May 18, 2022  
4591.00

**Re: 518 and 540 South Avenue Comprehensive Permit  
Responses to Review Comments on Groundwater Mounding**

**Response to J. Matthew Davis & Associates, LLC memorandum of April 28, 2022**

Grove Street, Dover, NH - Gravel Trench Water Depth (H) versus Infiltration Rate (f)

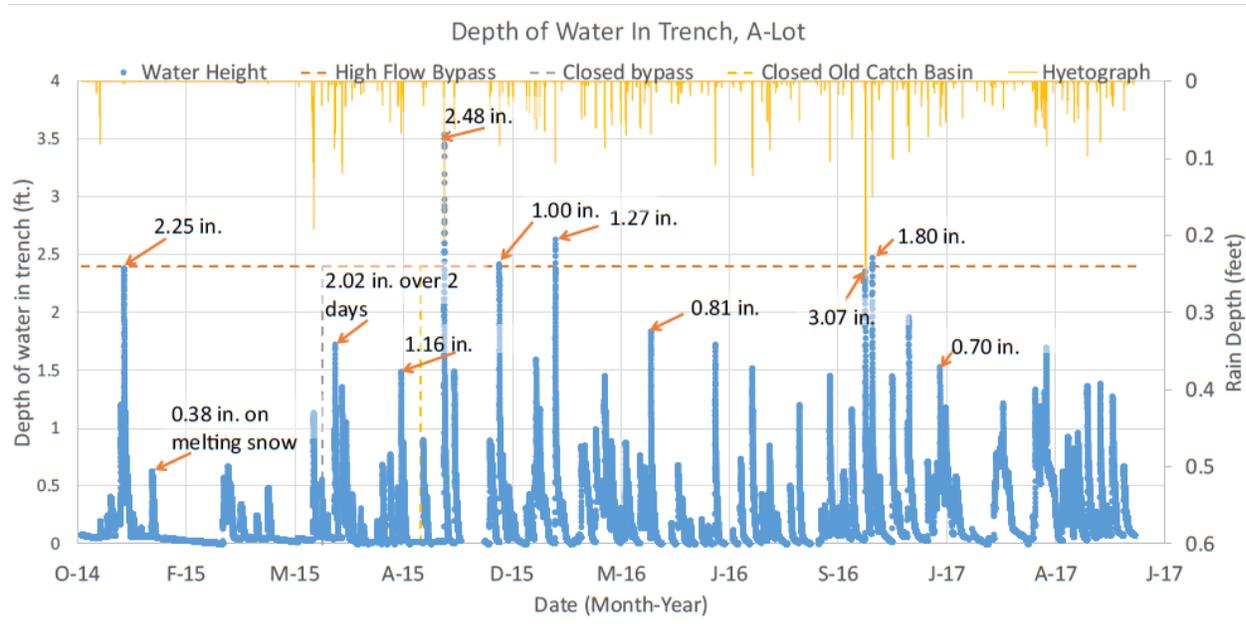
**Comment:** *The second argument focuses on the apparent assertion that the mounding heights simulated by the MODFLOW model overestimate the actual mounding as the model does not account for the 'bulb shaped wetting front' that would occur in the unsaturated zone, enabling both horizontal and vertical flow. Ballestero provides a lengthy explanation of the vertical and horizontal infiltration that can occur in an unsaturated zone beneath a saturated stormwater infiltration system. However, the concern expressed by reviewers is in regard to the saturated conditions when the groundwater mound rises into the stormwater chambers and does not involve an underlying zone of unsaturated material.*

*Under the saturated conditions simulated in the MODFLOW model, horizontal infiltration is already accounted for, so simulated mound heights are not over-predicted, as Ballestero suggests. In MODFLOW, recharge is added to the active model cell and flow is simulated in both horizontal and vertical directions, depending on the conditions in the aquifer. There is nothing in the previous or current versions of the MODFLOW model that would inhibit the horizontal flow through the side-wall 'wheepholes' [sic] in the proposed stormwater chambers. To model the infiltration chambers with hydraulically restrictive walls would require explicit treatment of the chambers as hydraulic barriers using, for example, the Horizontal Flow Barrier (HFB) package. There is no reference in the SHA report that the HFB package is used to inhibit flow through the sides of the stormwater infiltration areas, so horizontal infiltration from the stormwater chambers is already accounted for in the groundwater model.*

**Response:** The Massachusetts Stormwater Handbook which establishes the standard of practice for design of the stormwater basins does not prohibit the groundwater mound from rising into the chambers and Dr. Ballestero has pointed out in detail why the function of the chambers is not compromised should this occur.

On previous occasions the Board was presented infiltration data from the Horne Street, Dover, NH bioretention system (Macadam Thesis, UNH) that demonstrated significant lateral infiltration, especially as water in the system built up. Peer reviewers continue deny this fact of stormwater infiltration systems yet offer nothing more than opinion. The following are data from two more stormwater systems.

The Grove Street, Dover, NH system is a gravel trench constructed below a road. Stormwater runoff enters the system via street catch basins. The primary outlet for the stormwater is infiltration. Should the system fill-up, there is an overflow pipe that leads to a nearby stream where stormwater flowed unabated prior to the installation of the gravel trench system. Water level monitoring data indicated that the infiltration rate increased dramatically as water ponded in the system. Estimates of infiltration using various models indicate that on average, 84 percent of the water infiltrated out the sides rather than the bottom of the system (Ely Thesis, UNH)
